Re: FortisBC Energy Inc. (FEI)

Application for Approval of a Certificate of Public Convenience and Necessity (CPCN) for the Okanagan Capacity Mitigation Project (OCMP) (Application)

Response to the British Columbia Utilities Commission (BCUC) Information Request (IR) No. 1

Figure 1. 2023 Peak Demand Forecast

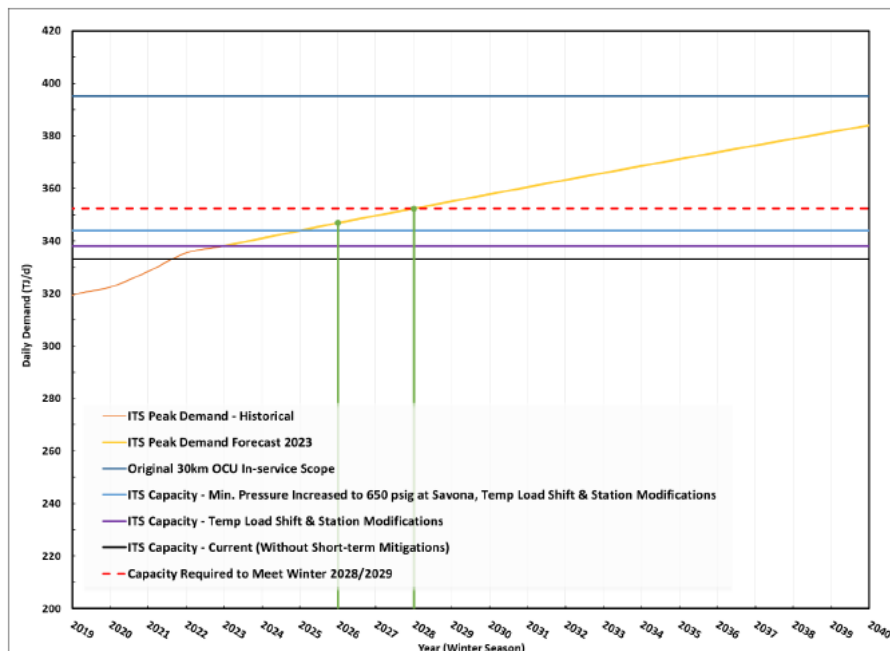
On page 11 of FortisBC Energy Inc.'s (FEI) Application for a Certificate of Public Convenience and Necessity (CPCN) for the Okanagan Capacity Mitigation Project (Application), FEI provides the 2023 Peak Demand Forecast that it relies on to confirm the need for Okanagan Capacity Mitigation Project (OCMP), as reproduced below. Further, FEI states that "[A]s the OCMP focuses on near term need, FEI considers it reasonable to use the most recent 2023 Peak Demand Forecast to define the scope of the Project."

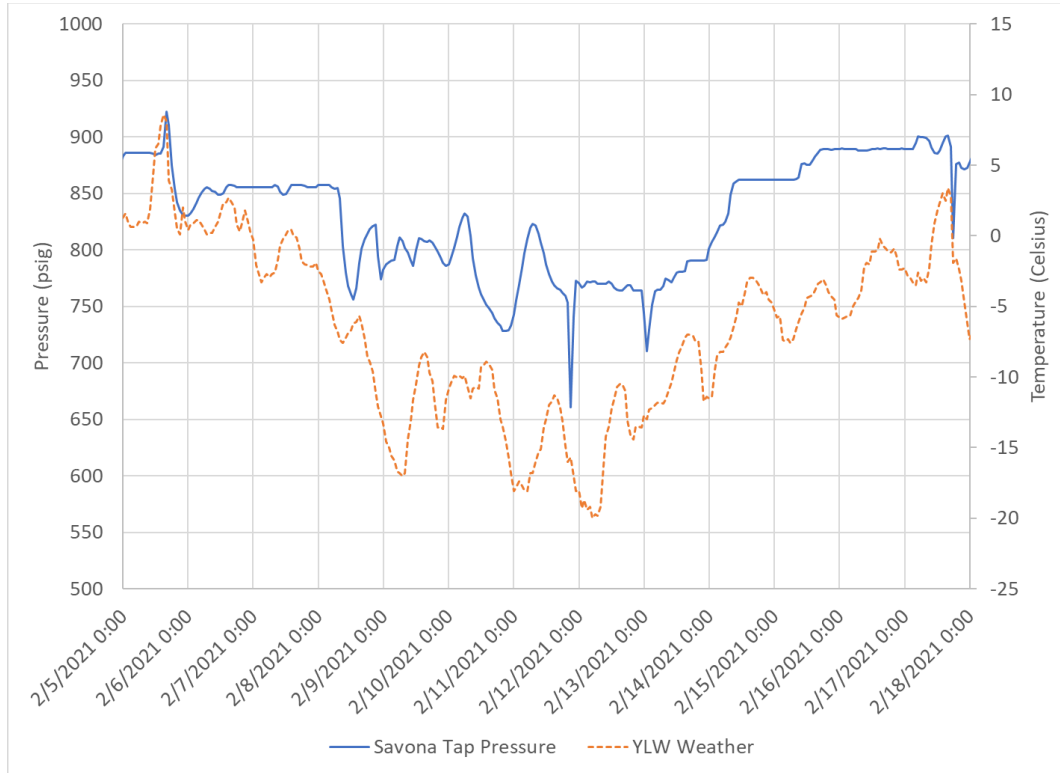
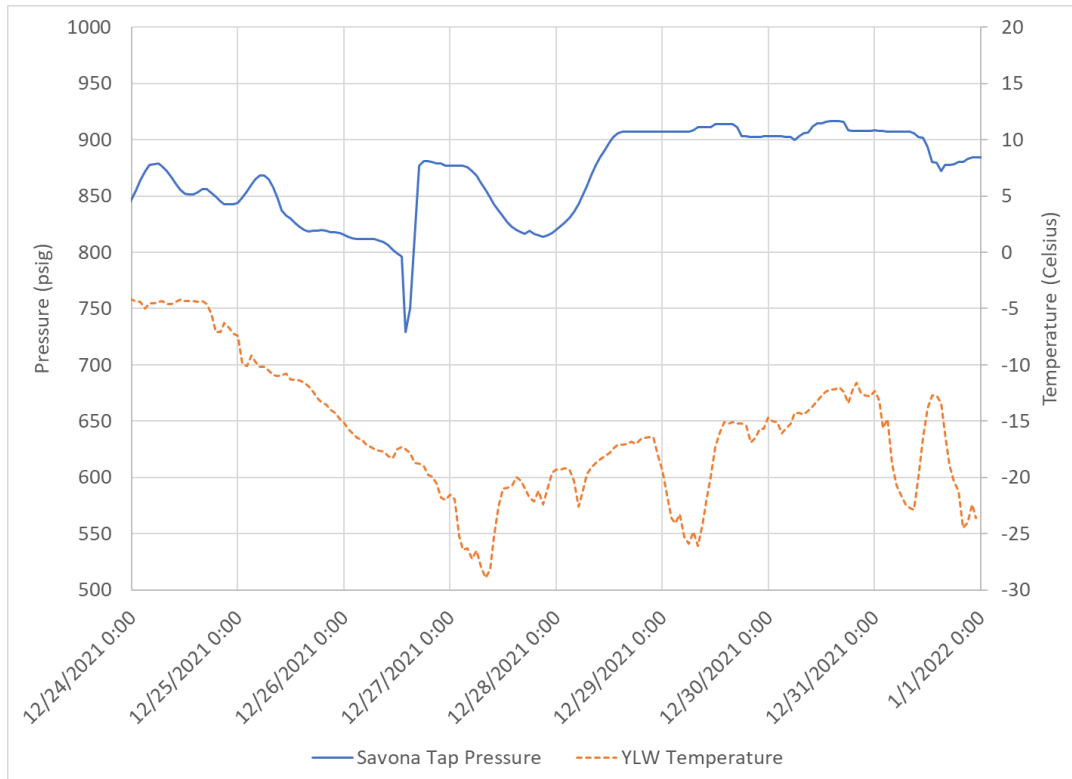
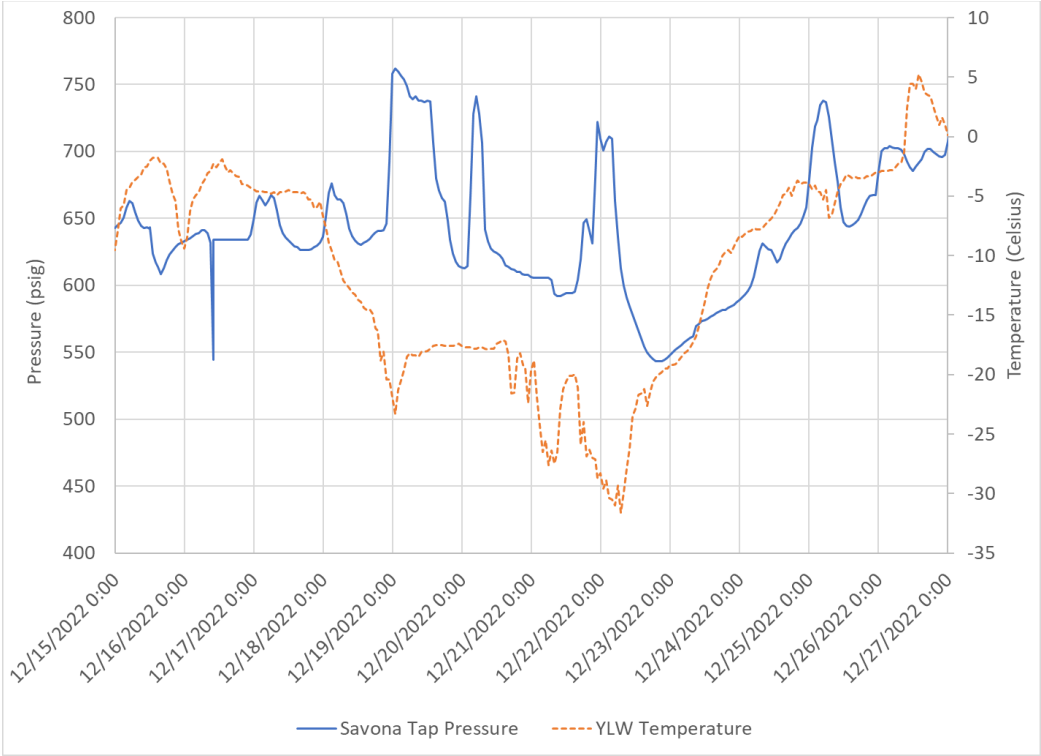
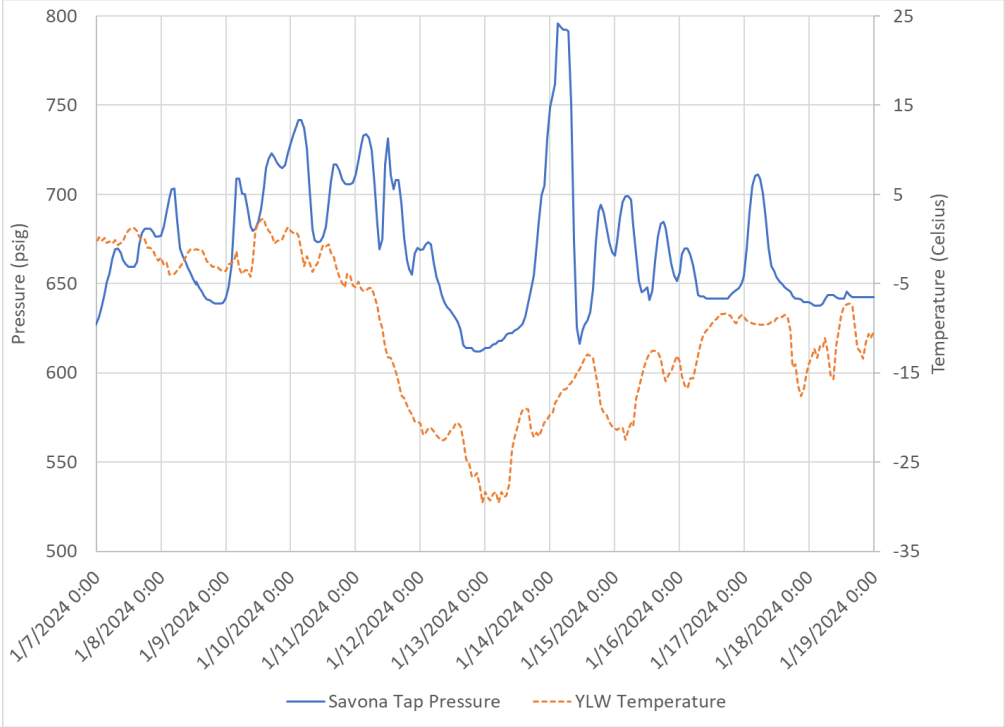
5.4 Please provide historical data on the actual tap pressure maintained by Enbridge at the Savona custody transfer point during peak winter demand periods since April 1, 2020.

The following figures show historic Savona tap hourly average pressure and Kelowna hourly temperatures through the following identified periods of peak winter demand since April 2020:
